**Rio Mesa Solar Electric Generating Facility (RMSEGF)
(11-AFC-4)**

**Applicant's General Comments and Comments to Conditions of Certification
on the Preliminary Staff Assessment**

SOURCE: Google Earth		BIOLOGICAL RESOURCES 1 AERIAL PHOTOGRAPH OF SOLAR ONE FACILITY		
URS	NO SCALE	CREATED BY: NJ	DATE: 11-15-12	FIG. NO: BR-1
		PM: AL	PROJ. NO: 27652105.00513

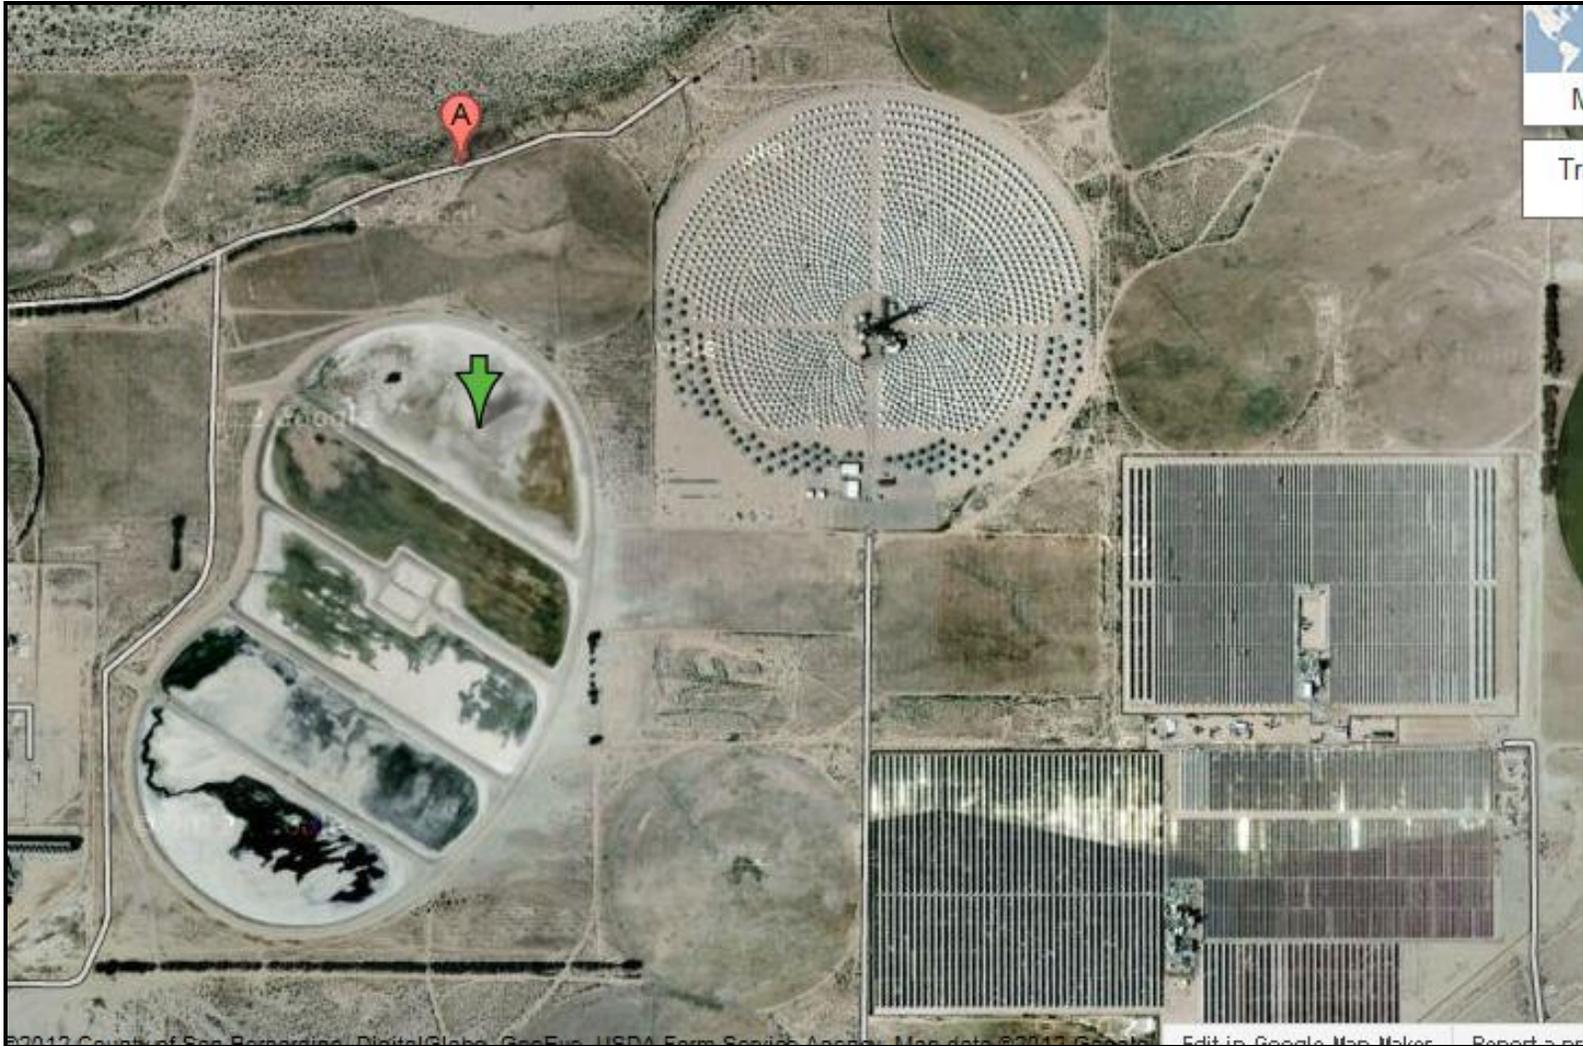
- b. Several of the species observed at Solar One have not been observed at or in the vicinity of the Rio Mesa site, including several waterbirds that appear to have been attracted by the artificial water sources adjacent to the Solar One plant. It is not appropriate to extrapolate collision risks from the Solar One plant for other locations where a different range of species is known to occur.

- c. The use of the McCrary study does not control for the relative abundance of birds on each site. The McCrary study indicates that the daily average count of birds over a 370 acre survey area was approximately 314, or 0.8 birds per acre. This is a very high bird density and is likely related to the unique proximity of artificial water sources near the plant.
